BIRRIWA SOLAR AND BATTERY PROJECT

Submissions Report

J210553 Birriwa Solar and Battery Project - Submissions Report

September 2023

Birriwa Solar and Battery Project
Submissions Report
Figure 5.2

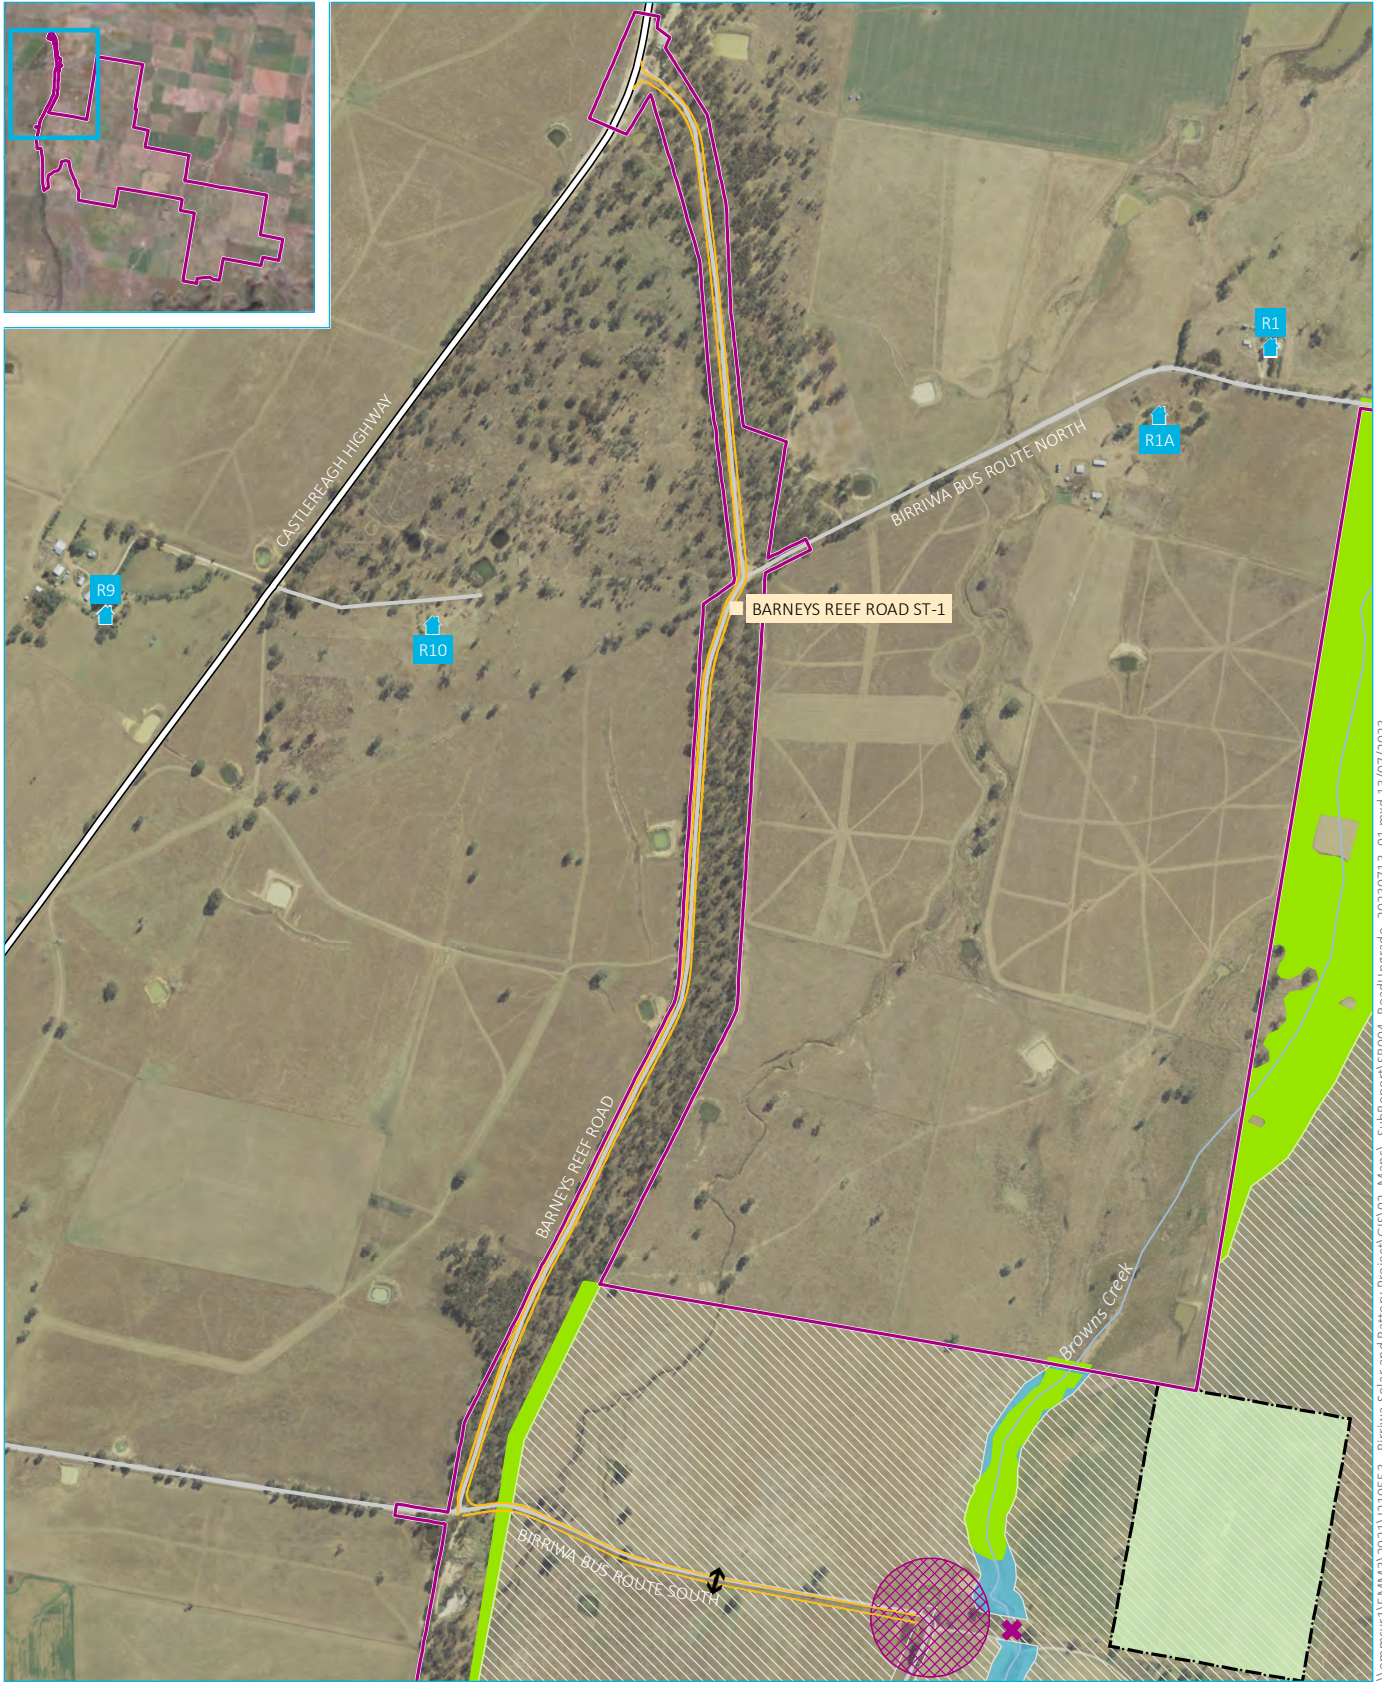
Five submitters (1% of total public submissions) raised concerns with the existing road conditions and the proposed road upgrades and continued maintenance to sustain the project.

One submitter had questioned who would be responsible for the costs associated with the road upgrades and maintenance, as well the existing road's ability to sustain the project.

To accommodate the construction traffic movements associated with the project, an upgrade of Barneys Reef Road and Birriwa Bus Route South along the project access route will be required (refer to Figure 5.2). Resurfacing and widening will be completed on Barneys Reef Road and Birriwa Bus Route South in compliance with Austroads rural roads design standards, and in further consultation with relevant authorities during subsequent phases of project design and assessment. The costs associated with the public road upgrades for the purpose of accessing the project will be borne by ACEN. Note, council would maintain the local public roads post-construction and TfNSW would maintain the State Highway. Further, in relation to ongoing road maintenance, as noted above, ACEN will enter into a VPA with Mid-Western Regional Council, the purpose of which is to support the cost of maintenance of services such as local roads. In addition, upgrades to roads that will be undertaken across the CWO REZ, such as Barneys Reef Road and the intersection with the Castlereagh Highway for this project, will increase the quality of the roads across the region and subsequently lead to better safety outcomes for the community.

Birriwa Solar and Battery Project
 Submissions Report
 Figure 5.4

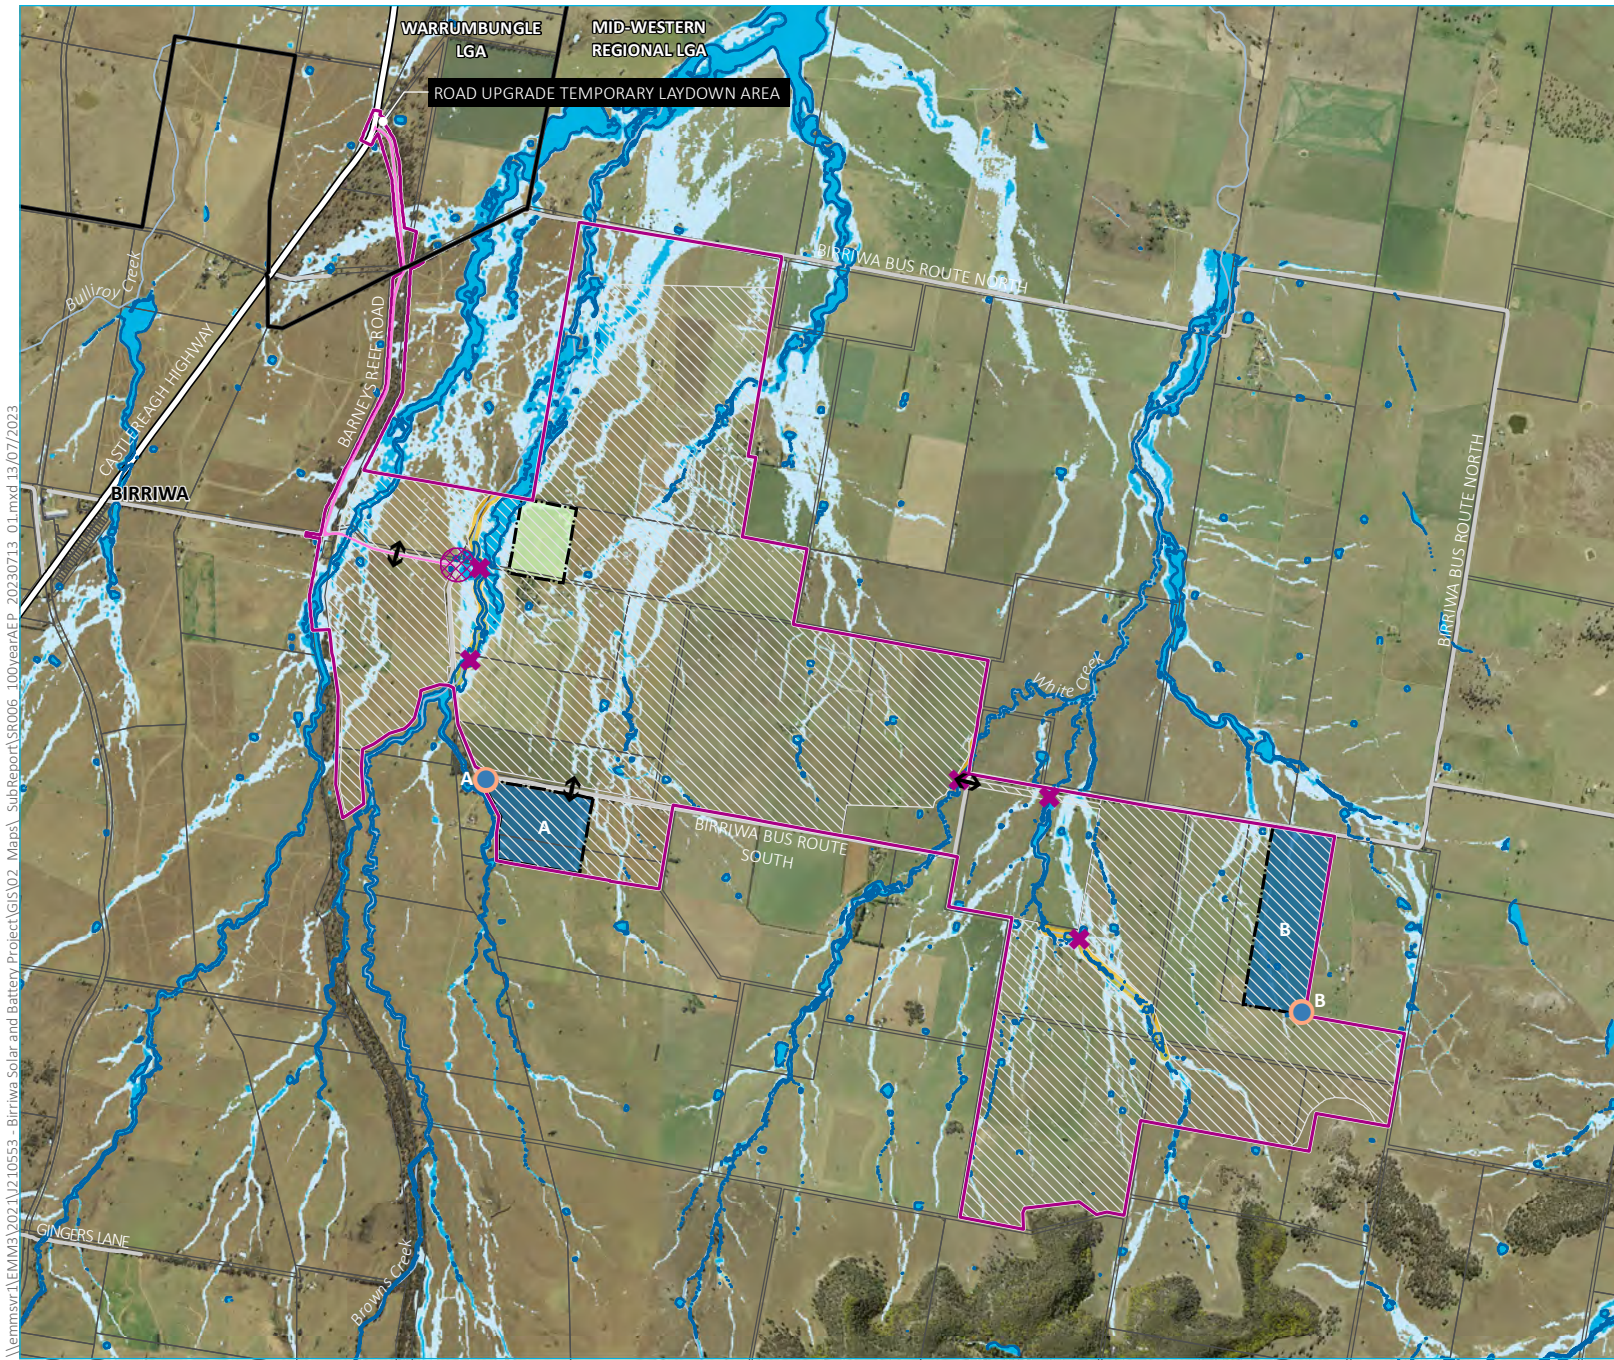
Four submitters (1% of total public submissions) raised potential concerns that the project may increase flood impacts. One submitter raised concerns about how the roads and creeks will handle the increased amounts of water when it rains.

Flood modelling was undertaken for the project to provide planning guidance for the placement of internal infrastructure and to assess the potential for external impacts. Flood modelling of the existing conditions was undertaken for a range of annual exceedance probability events for the study area. The output of this modelling provides guidance on the planning of project infrastructure and enables the assessment of external impacts which may occur due to the project. Modelling results show that the project is likely to result in a minor increase in the volume of surface flow being discharged from the study area (refer to Figure 5.4).

Flood prone areas have been mapped across the study area and areas of higher flood risk identified. Due to the small extent of the project at the ground level, the impacts of the project to flood depth, velocities and levels will be small. For proposed site infrastructure outside the primary flow paths, flood impacts are considered to be minor in all modelled events.
